Addendum 45 – Regulation No. 46

Revision 7 - Amendment 1

Supplement 1 to the 05 series of amendments – Date of entry into force: 22 September 2024

Uniform provisions concerning the approval of devices for indirect vision and of motor vehicles with regard to the installation of these devices

- (i) Edge of the reflecting surface enclosed in a protective housing
- (ii) Reflecting surface projects beyond the protective housing in a specific adjustment position
- (iii) Edge of the reflecting surface not enclosed by the protective housing

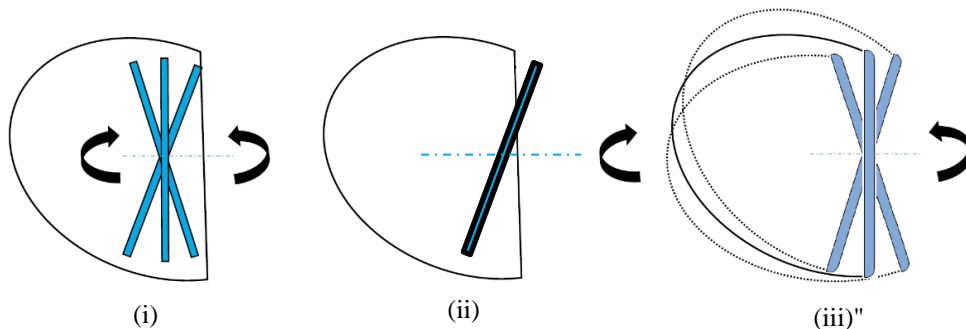
Paragraph 6.1.1.2., amend to read:

When the edge of the reflecting surface is enclosed in a protective housing, the radius of curvature 'c' on the housing's perimeter shall be not less than 2.5 mm at all points and in all directions, figure below (i).

When the reflecting surface projects beyond the protective housing in any adjustment position (figure below (ii)), the radius of curvature 'c' on the edge of the projecting part shall be not less than 2.5 mm and the reflecting surface shall return into the protective housing under a force of 50 N applied to the point of greatest projection, relative to the protective housing, in a horizontal direction, approximately parallel to the longitudinal median plane of the vehicle.

When the edge of the reflecting surface is not enclosed by the protective housing independent from any adjustment position, the radius of curvature 'c' on its perimeter shall be not less than 2.5 mm at all points and in all directions and shall apply to the edge of the projecting part, figure below (iii).

"Figure 9.1

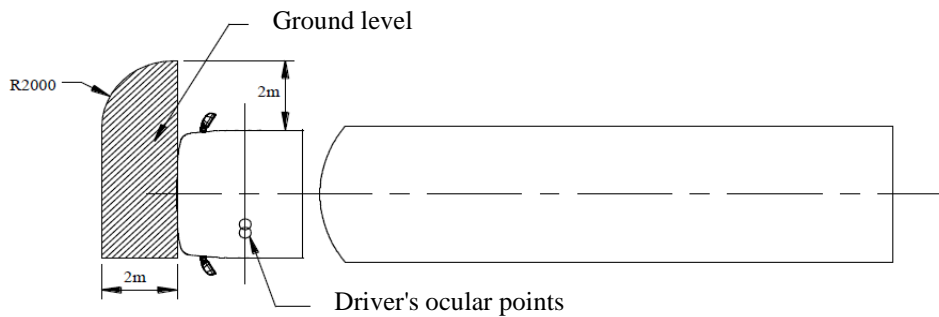
Paragraph 15.2.4.6.1., amend to read:

"15.2.4.6.1. The field of vision shall be such that the driver can see at least a flat horizontal portion of the road, which is for side-steered vehicles bounded by:

- (a) A transverse vertical plane through the outermost point of the front of the vehicle;
- (b) a transverse vertical plane 2,000 mm in front of the plane defined in (a);
- (c) a longitudinal vertical plane parallel to the longitudinal vertical median plane going through the outermost side of the vehicle at the driver's side;
- (d) a longitudinal vertical plane parallel to the longitudinal vertical median plane 2,000 mm outside the outermost side of the vehicle opposite to the driver's side; and
- (e) the front of this field of vision opposite to the driver's side may be rounded off with a radius of 2,000 mm (see Figure 9.1).

Figure 9, renumber as Figure 9.1. and amend to read:

"Figure 9.2
Class VI field of vision for centre-steered vehicle"

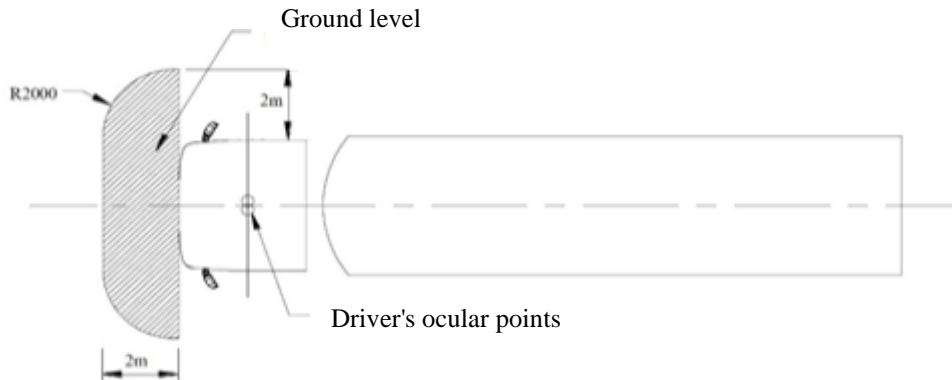
The field of vision shall be such that the driver can see at least a flat horizontal portion of the road, which is for centre-steered vehicles bounded by:

- (f) A transverse vertical plane through the outermost point of the front of the vehicle;
- (g) a transverse vertical plane 2,000 mm in front of the plane defined in (a);
- (h) a longitudinal vertical plane parallel to the longitudinal vertical median plane 2,000 mm outside the outermost side of both sides of the vehicle; and
- (i) the front of this field of vision on both sides may be rounded off with a radius of 2,000 mm (see Figure 9.2).

Insert a new figure 9.2., to read:
